Subject: Duke Energy Carolinas, LLC  
William States Lee III Nuclear Station – Docket Nos. 52-018 and 52-019  
AP1000 Combined License Application for the  
William States Lee III Nuclear Station Units 1 and 2  
Supplemental Response to Request for Additional Information  
Ltr# WLG2012.04-08

**Lee Nuclear Station Response to Request for Additional Information (RAI)**

**Reference NRC RAI Number: ER RAI 190 Supplement, Site Layout and Plant Description**

**Reference NRC RAI Number: ER RAI 210 Supplement, Ecology - Aquatic**

Updated ER Figure 5.3-1,  
River Water Intake Structure  
Sheets 1 through 7 of 7

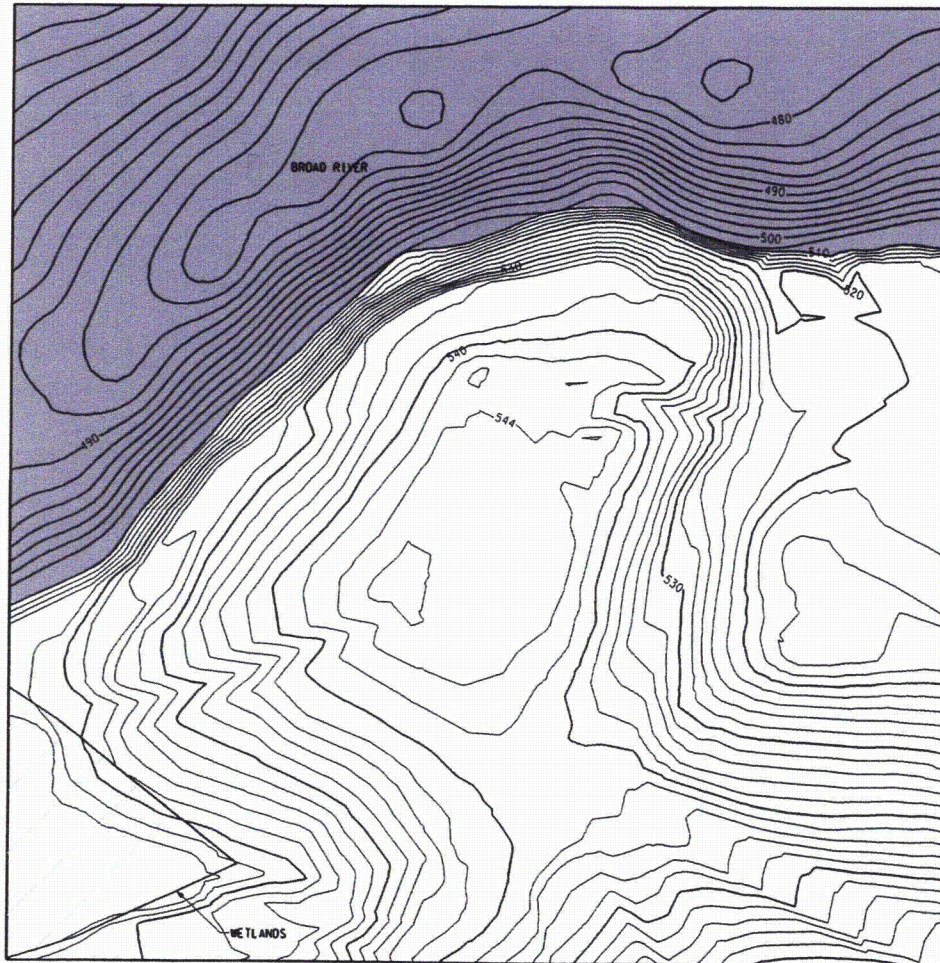
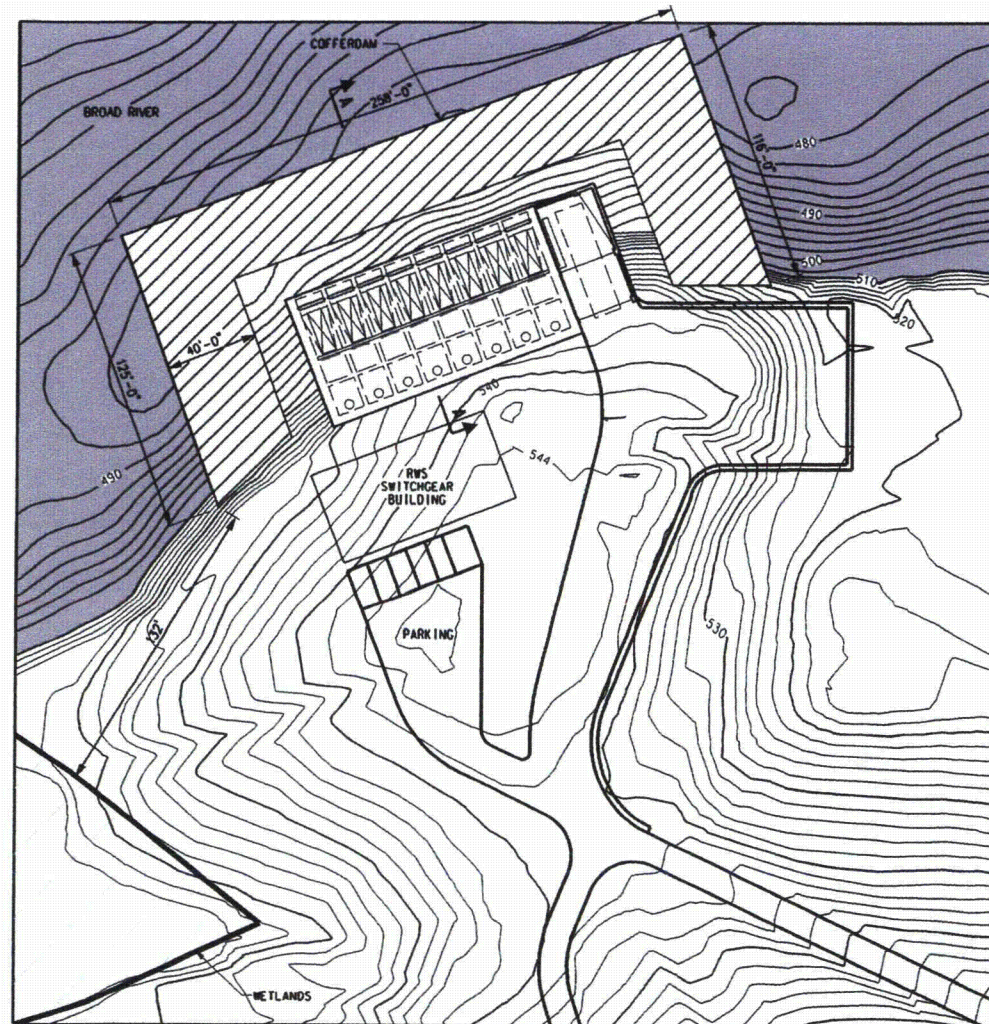
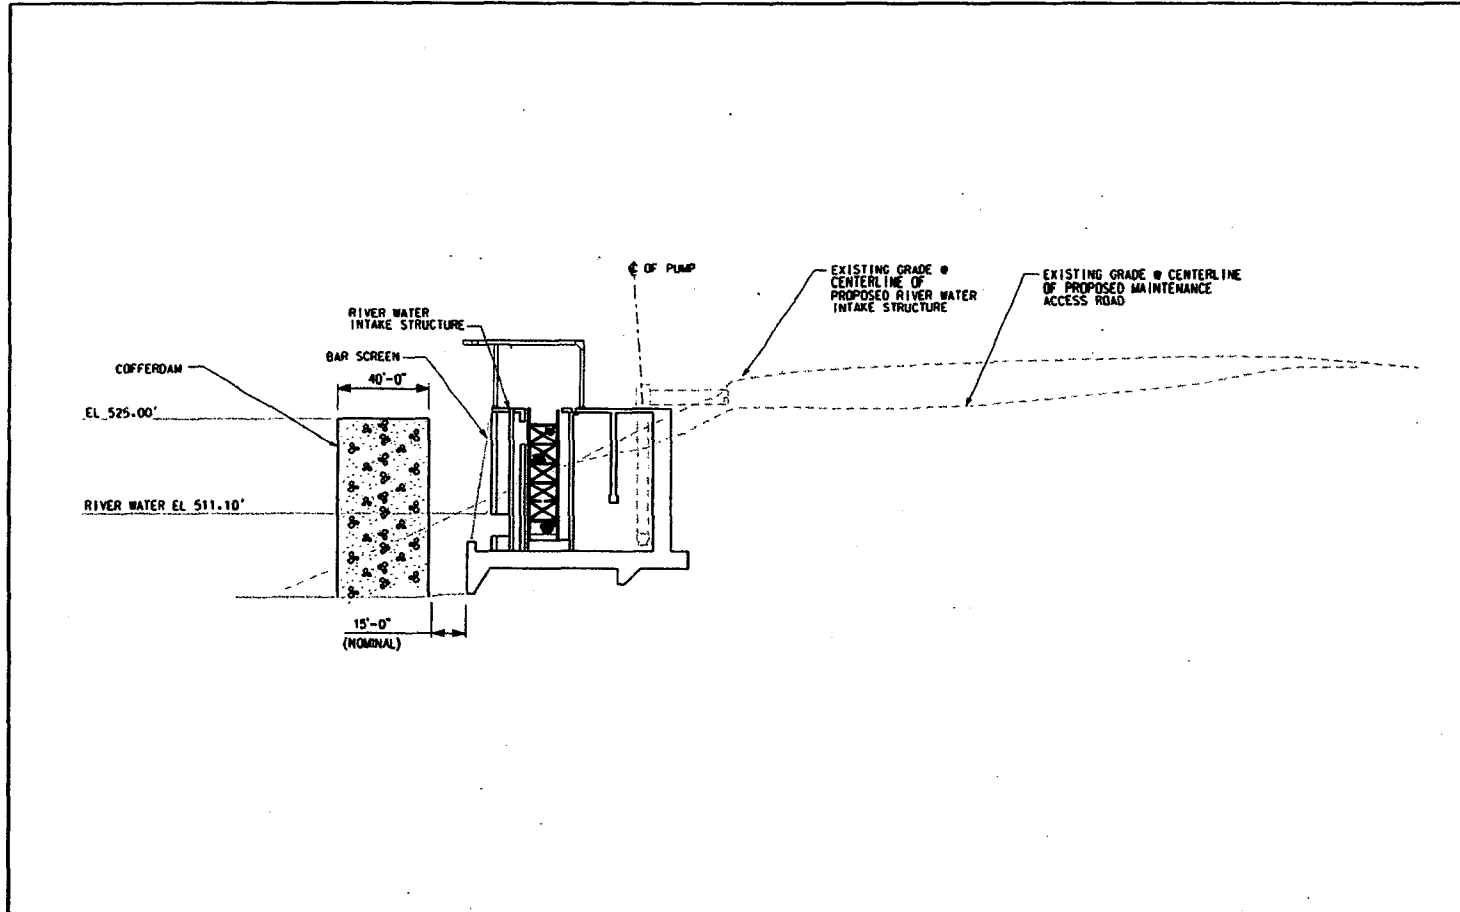
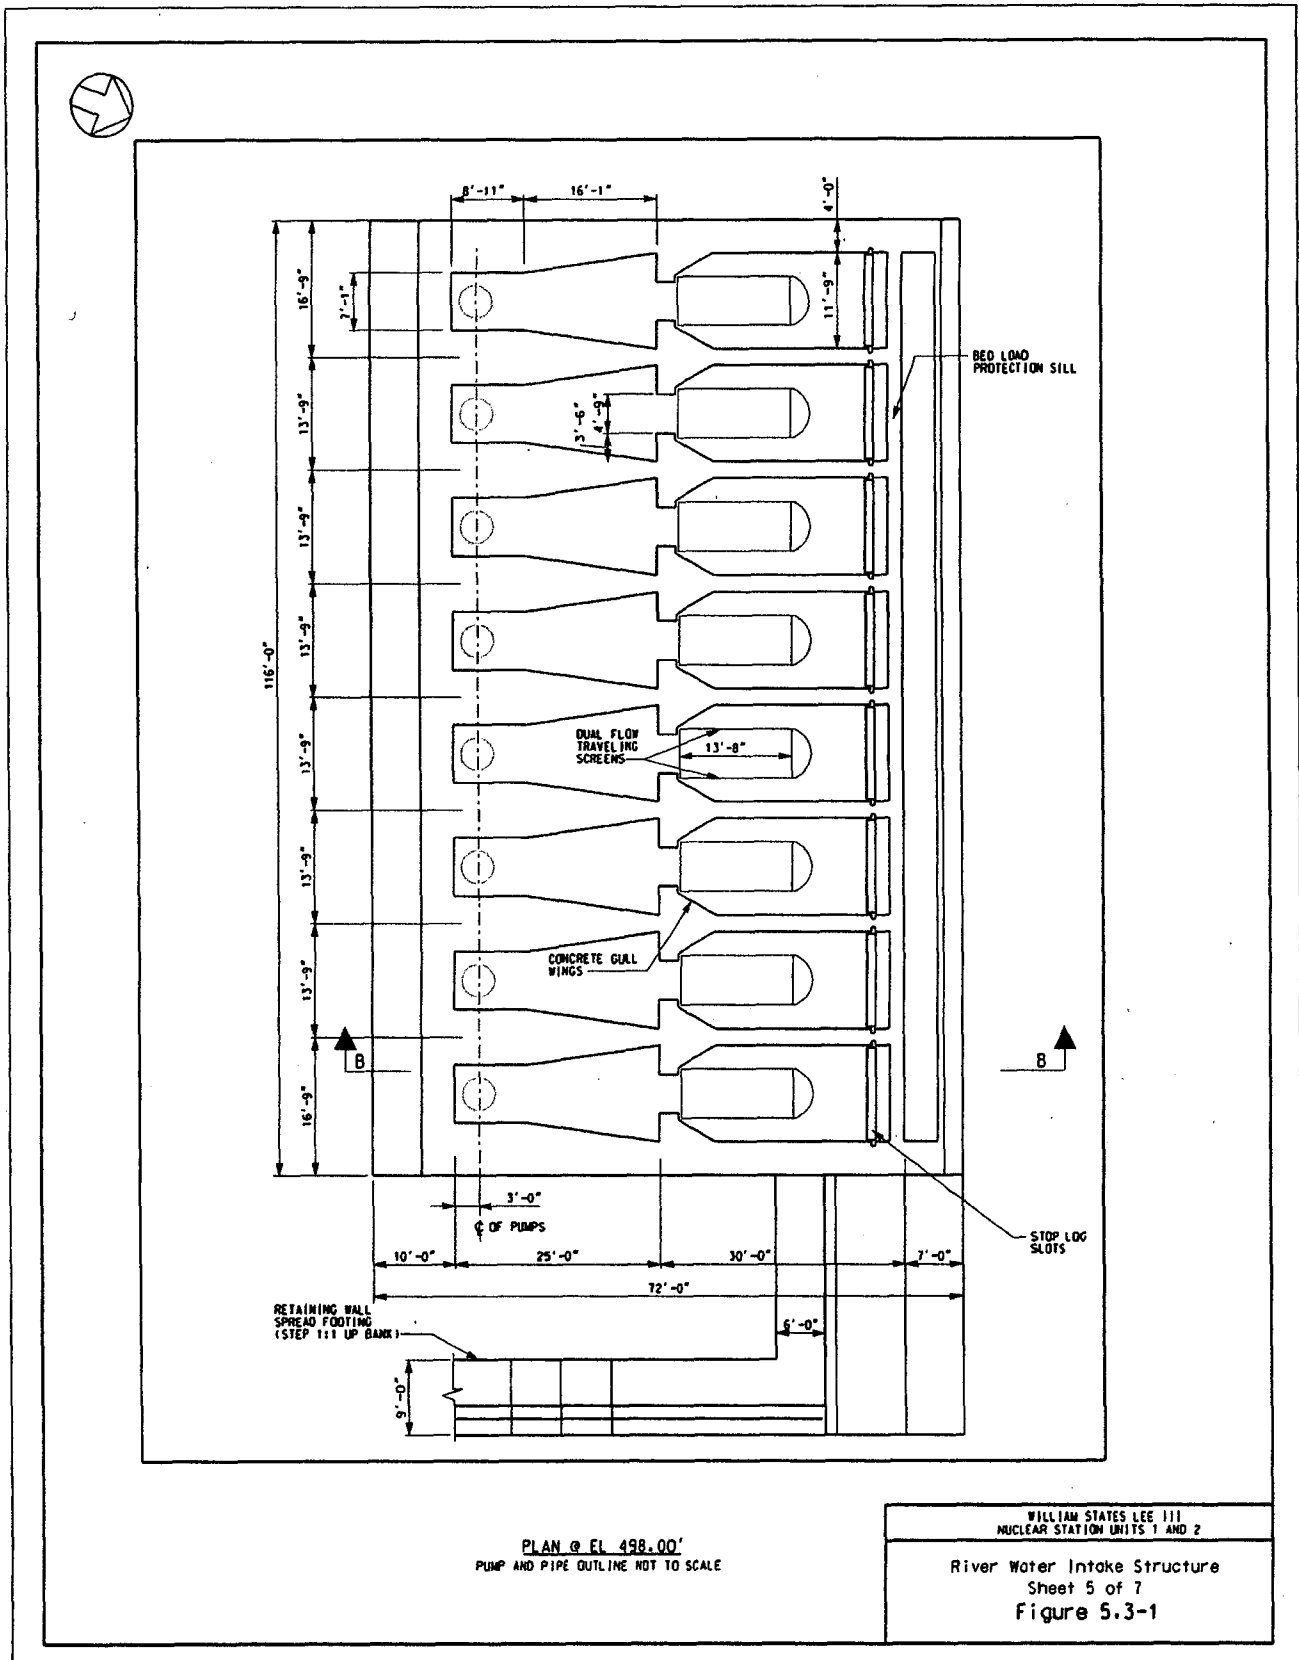
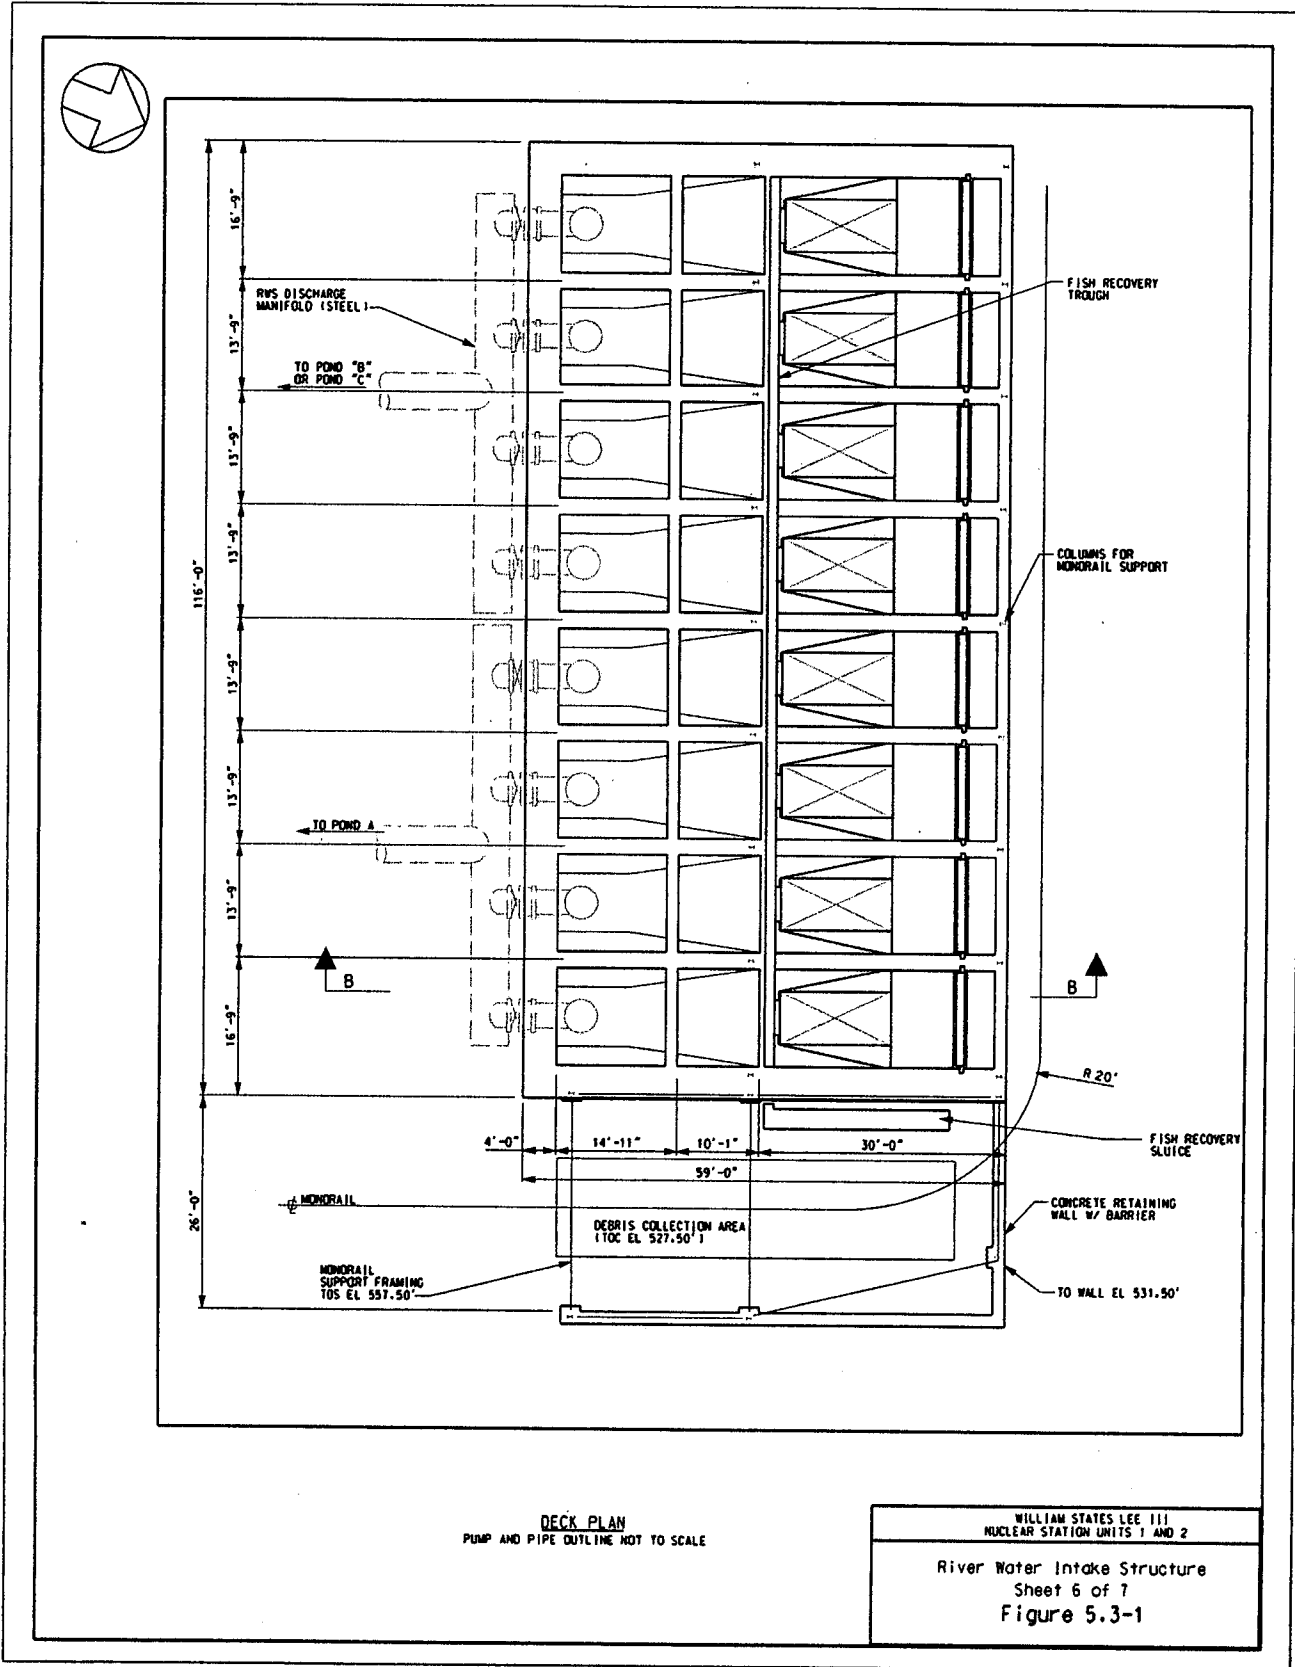
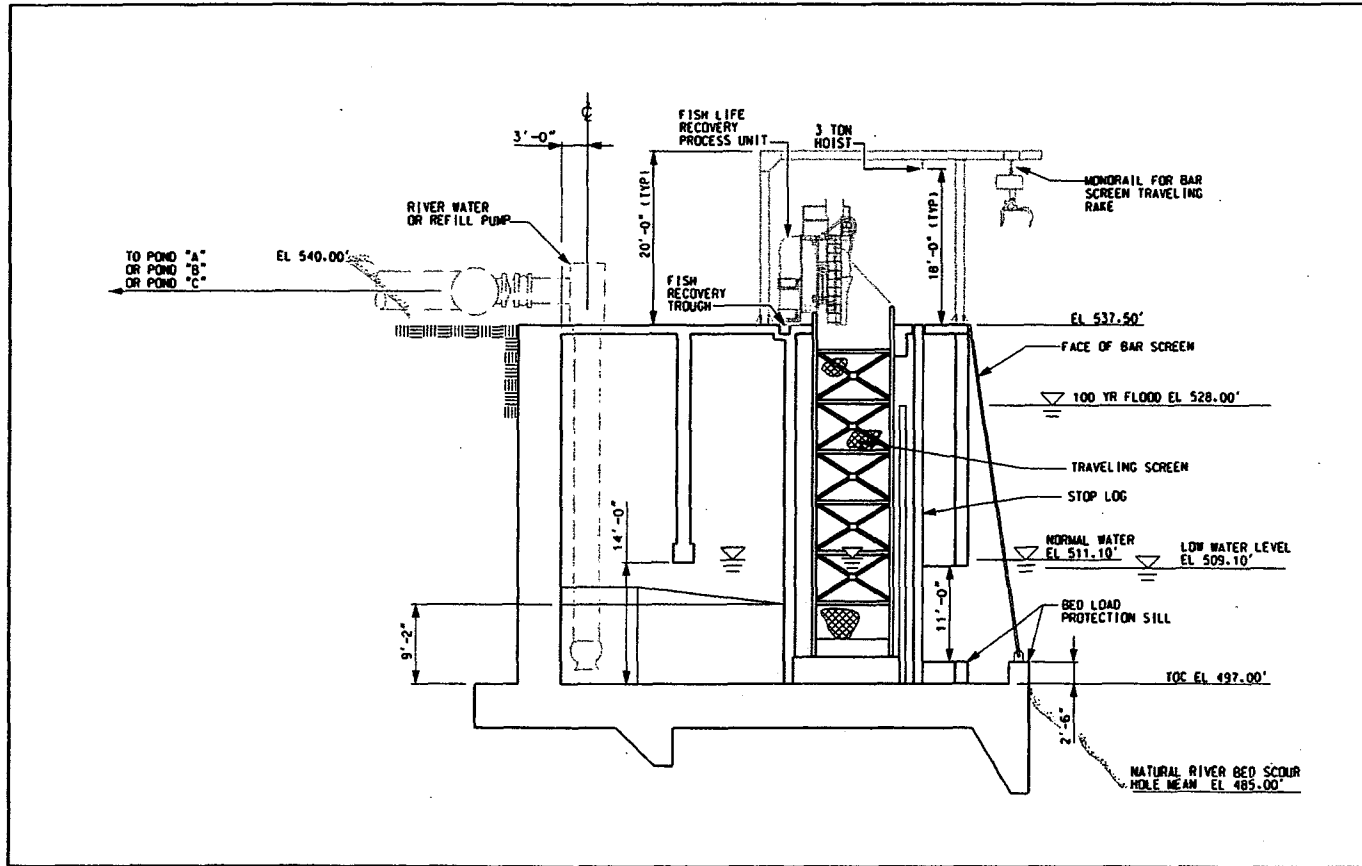
Provide physical descriptions (e.g., location, dimensions, construction materials, pump systems) of the "River Water Intake Subsystem" and the "Refill Subsystem Intake" referred to in Supplemental ER Figure 3.3-1, Sheets 1 and 2.

Additional details of the Dual Flow Traveling Screens and concrete walls have been added to the plan and section views of the River Water Intake Structure as reflected on ER Figure 5.3-1 (Attachment 190S-01). The width of the Dual Flow Traveling Screens have been changed from 20'-0" to 13'-8" as shown on ER Figure 5.3-1 Sheet 5 of 7 (Attachment 190S-01). Updated calculations have confirmed that through-screen velocity on these Dual Flow Traveling Screens will be less than 0.5 ft/sec.

Updated Raw Water System  
Water Transfer Diagram

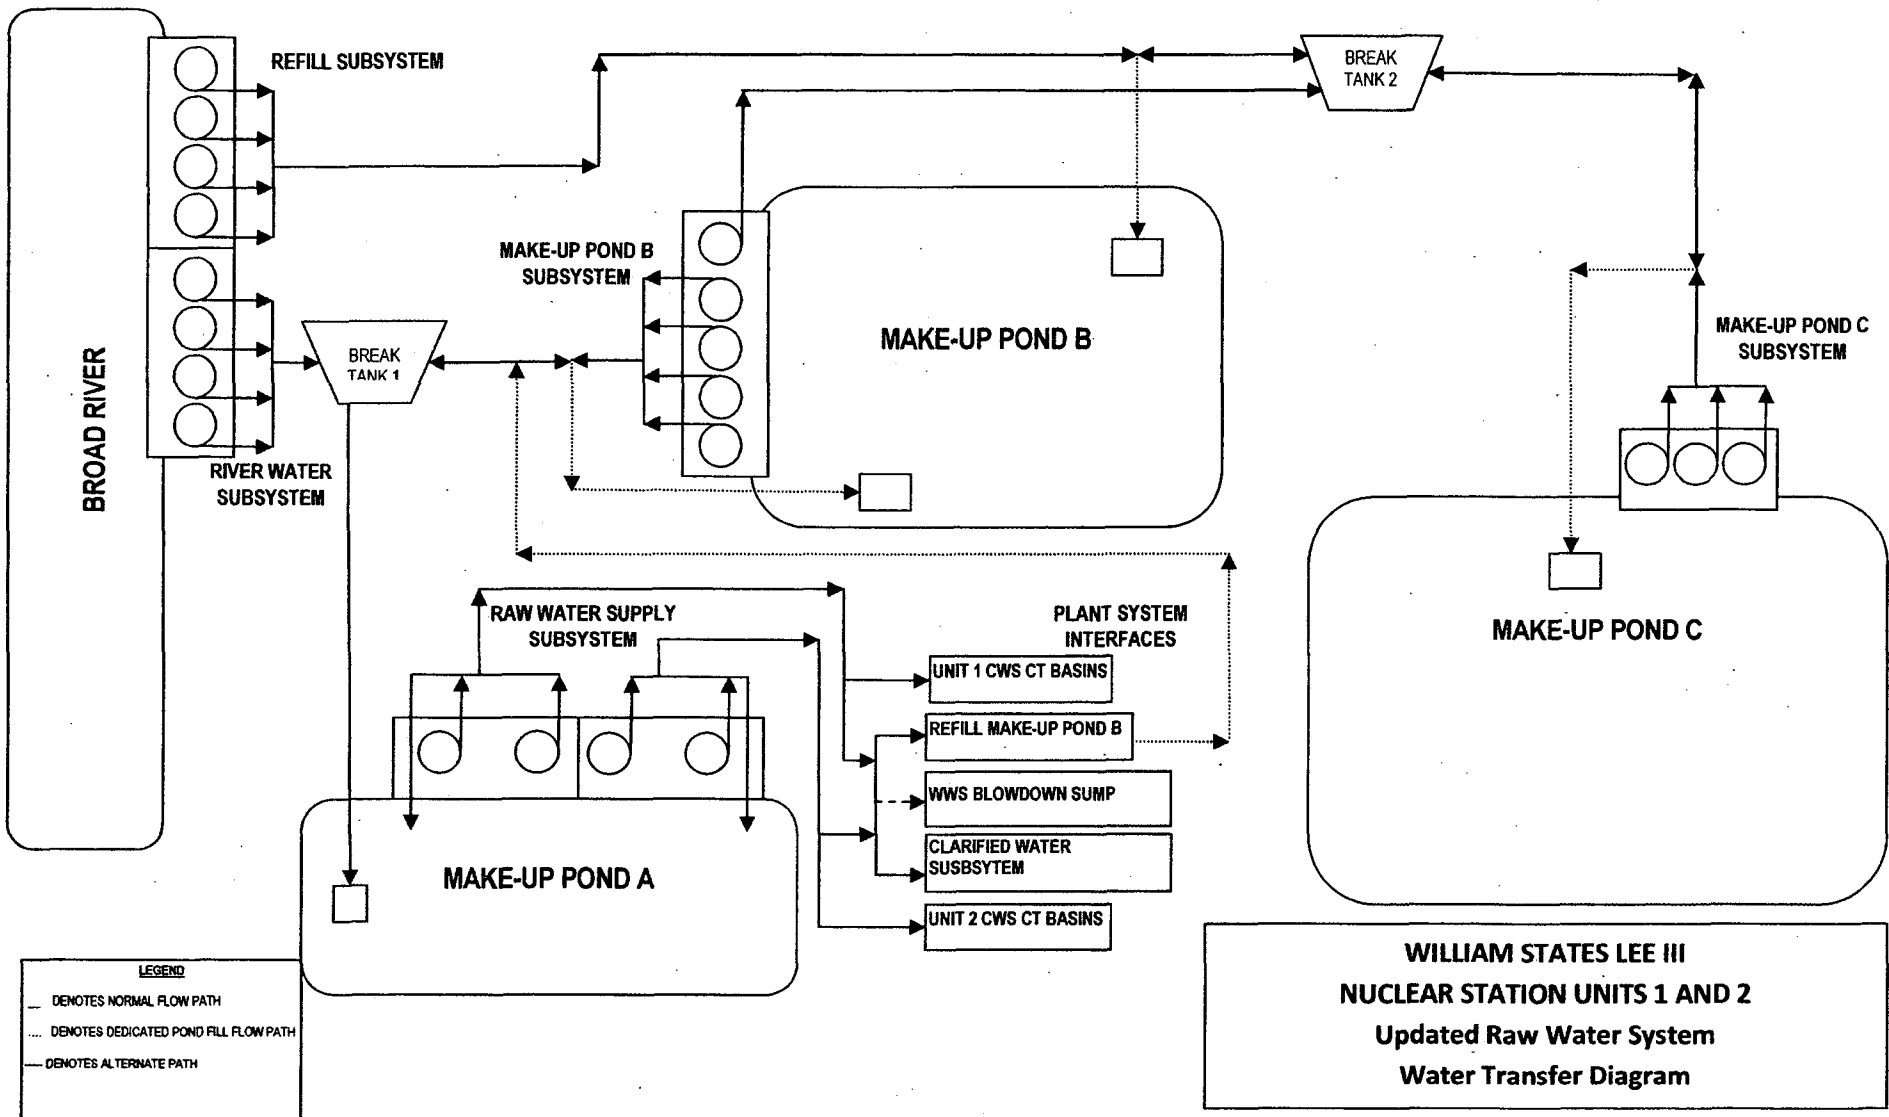
Discuss any changes to the site preparation and construction methods, affected area, spoils volume and disposition, timing, and duration for the river intake and associated distribution systems. Provide a narrative description of the relationship or interconnections between these intake(s) and the various Make-Up ponds, including the expected flow rate and duration of refill pumping operations.

The number of pumps/pump bays in the Make-Up Pond A Intake Structure have changed from six (6) to four (4). The Raw Water System Water Transfer Diagram (previously provided with Reference 1) has been updated to reflect these changes and is provided as Attachment 190S-02. An updated drawing of the Make-Up Pond A Intake Structure is provided in Enclosure 2 to this letter.
